Docket Item # 11
BAR CASE # 2008-0135

BAR Meeting
September 3, 2008

ISSUE: Alterations
APPLICANT: London Bob Hair Design
LOCATION: 415 South Washington Street
ZONE: CL Commercial

Figure 1: 415 South Washington Street front facade and awning specs.

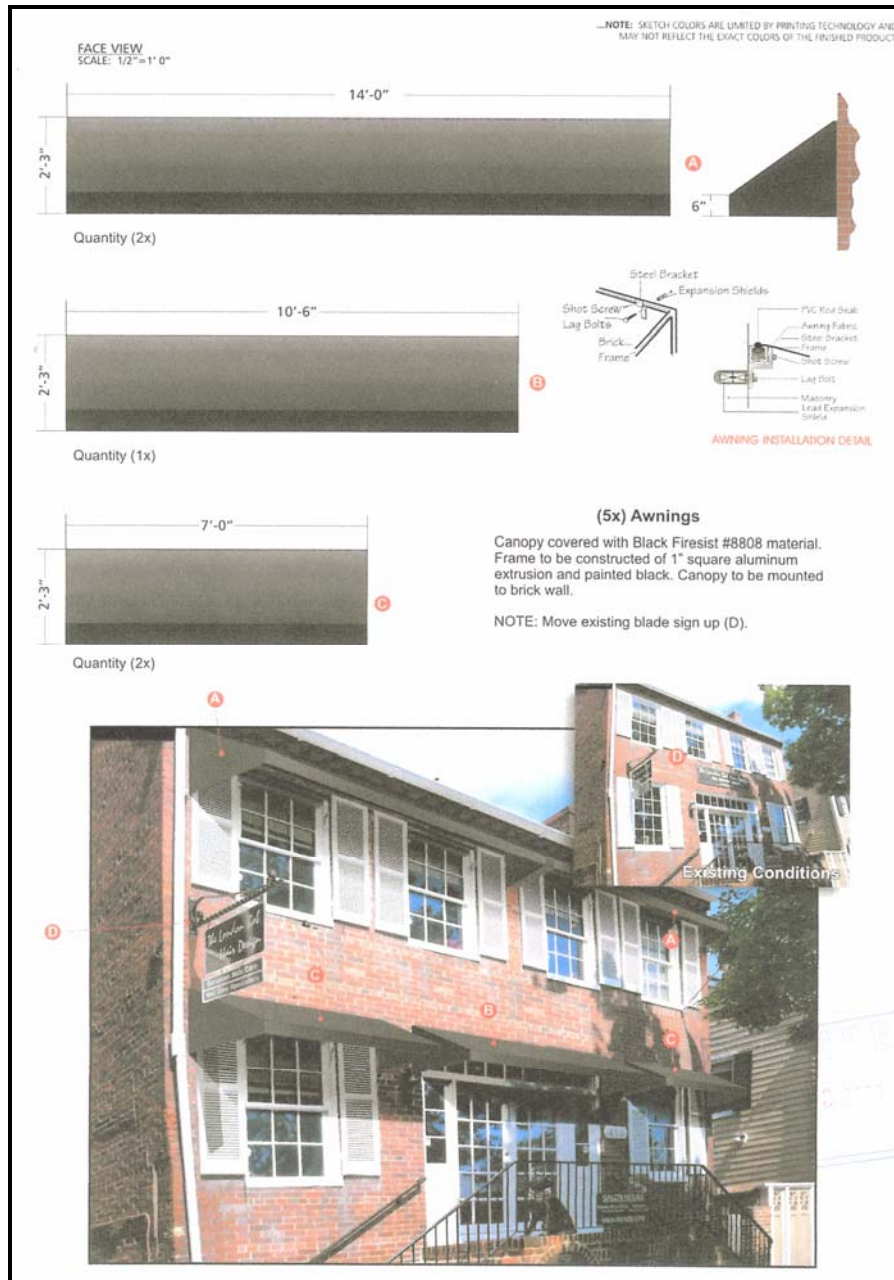
Proposed awnings comply with the zoning ordinance conditional upon the installation of the awnings not lower than 7 feet above the sidewalk in accordance with building code comments.

While some awnings may be appropriate for this building, Staff is concerned about the number of proposed awnings and how the proposed awnings may impact the existing shutters and possibly the cornice. According to the design guidelines, awnings should be appropriate and sympathetic to the historical style of the building to which they are attached. While Staff understands the desire of the applicant to install awnings to reduce energy costs from direct eastern sun, Staff recommends a deferral in order to explore reducing the number of proposed awnings and how they will impact the façade, especially the existing shutters and cornice.

- C-1 Awnings must comply with all applicable requirements of USBC 3105.3 and 3202.3.1. Retractable and fixed awnings must have a minimum 7 foot clearance from a sidewalk to the lowest part of the framework or any fixed portion of any retractable awning is required. Retractable awnings must be securely fastened to the building and can not extend closer than 24 inches in from the curb line (USBC 3202.3.1).
- C-2 Fixed awnings must be designed and constructed to withstand wind or other lateral loads and live loads required by the USBC. Structural members must be protected to prevent deterioration (USBC 3105.3).
- C-3 Construction permits are required for this project. Plans shall accompany the permit application that fully details the construction as well as layouts and schematics of the mechanical, electrical, and plumbing systems.

Staff recommends deferral for restudy.
